### MEMORANDUM

**SUBJECT:** Compark Village South Major Amendment-Belford Ave and Bridge (SP21-028)

## SITE IMPROVEMENT PLAN - AMENDMENT NO. 1

## Belford Avenue Streetscape Conceptual Planting Design

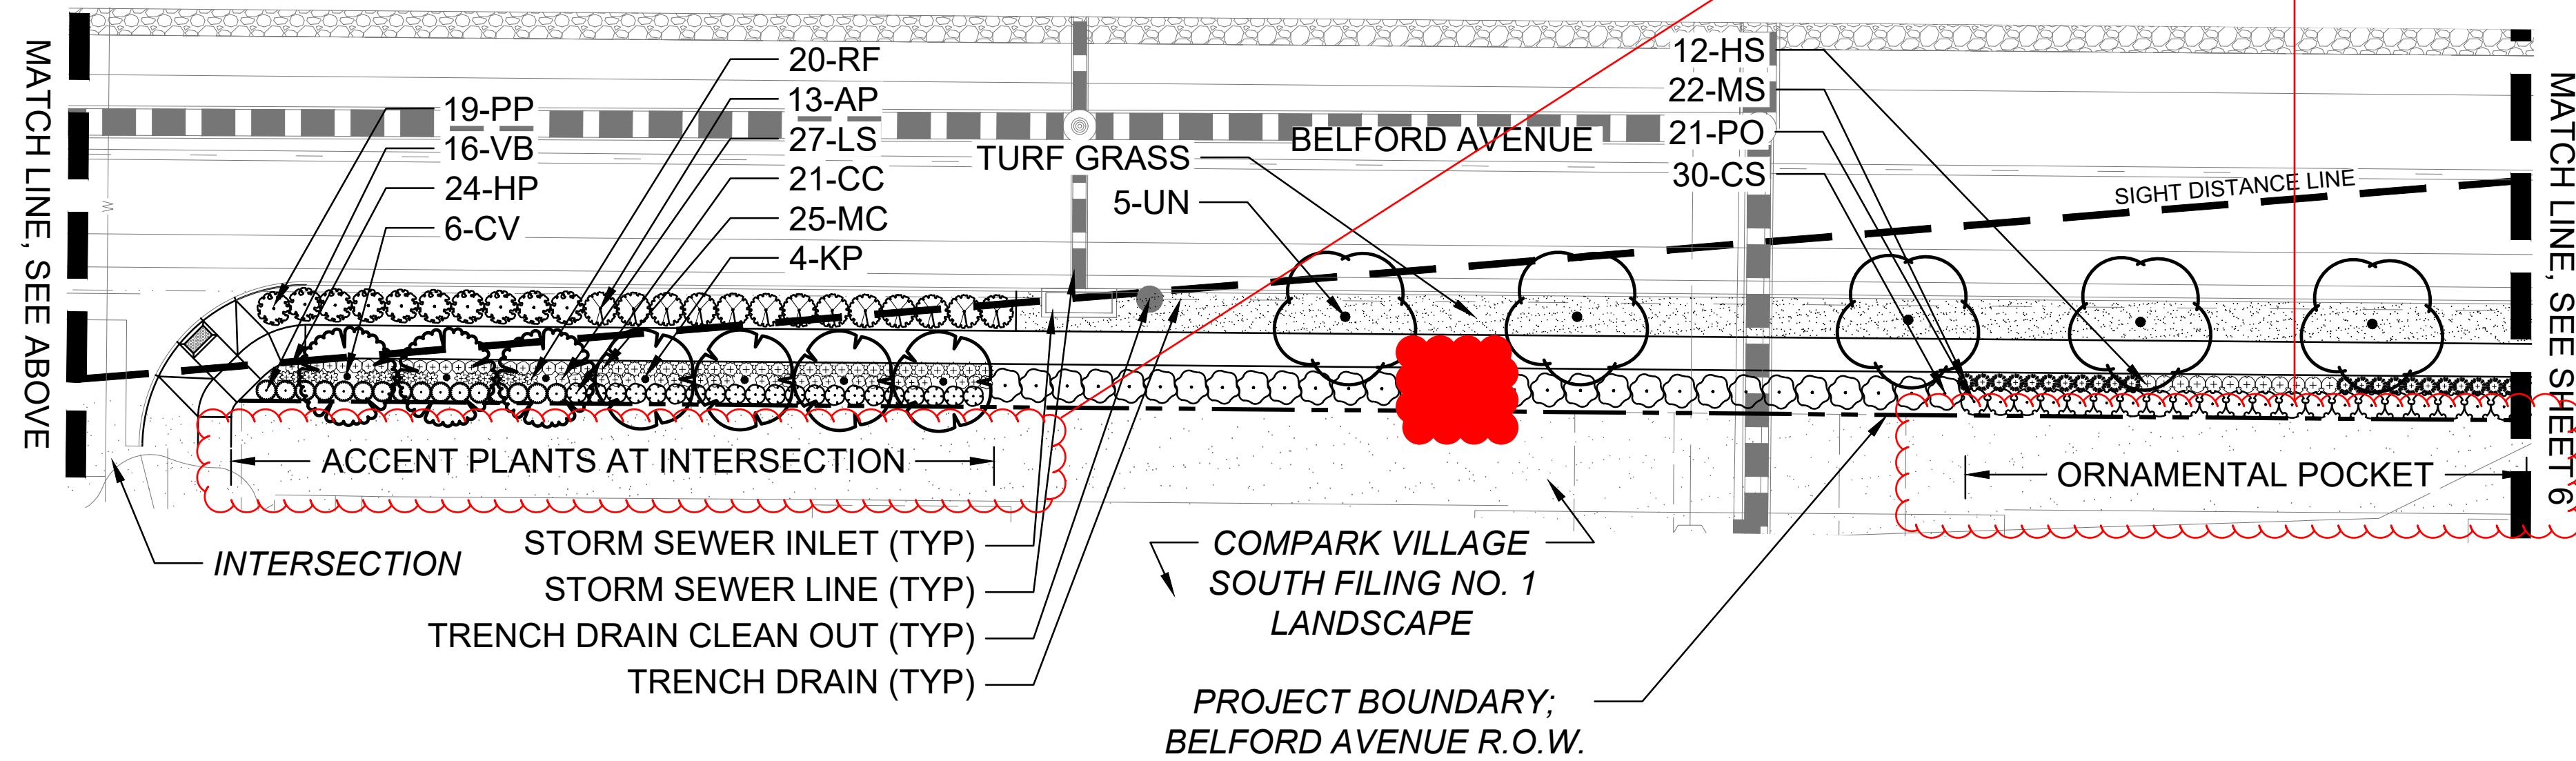
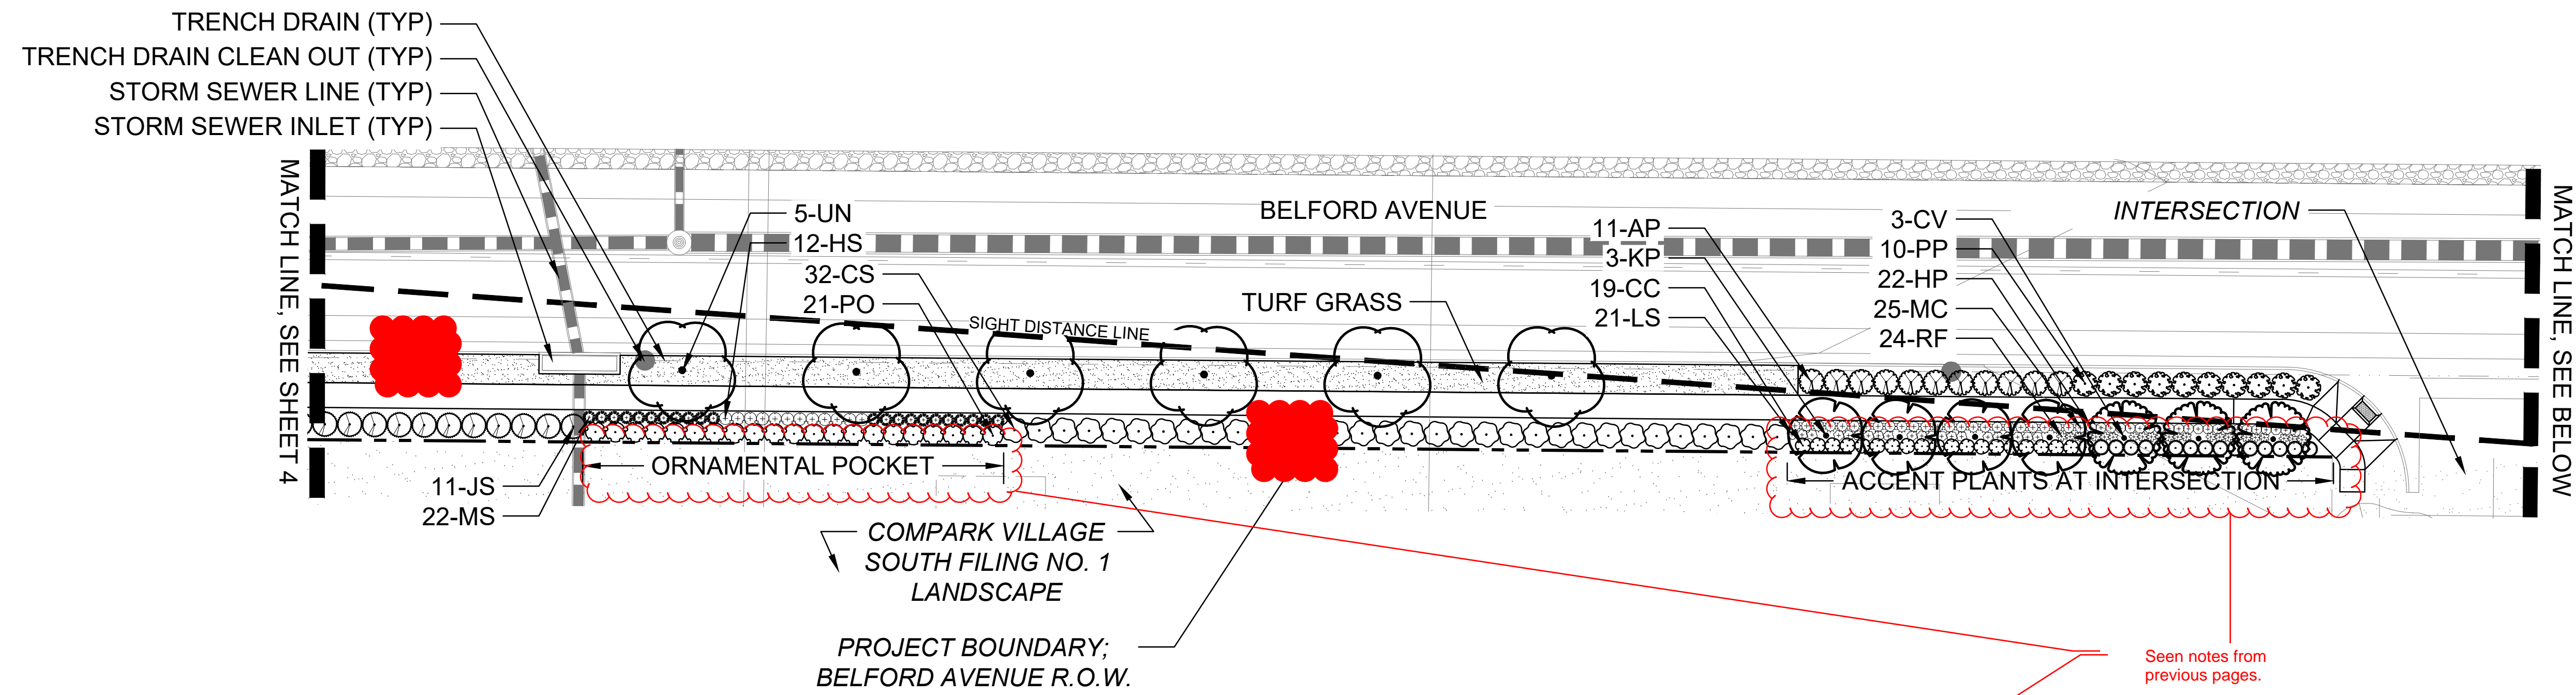
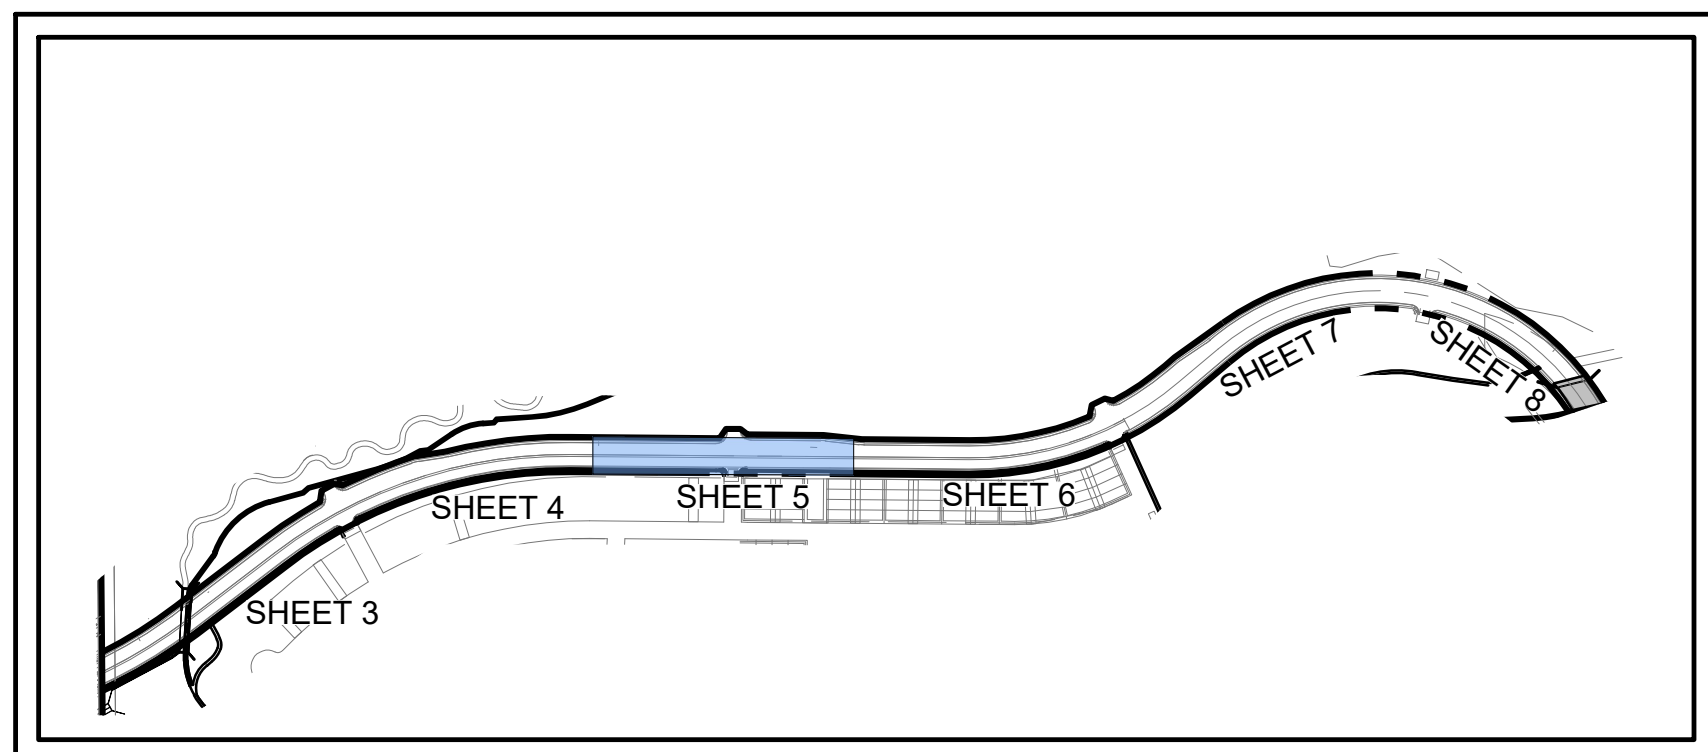
Seen notes from previous pages.
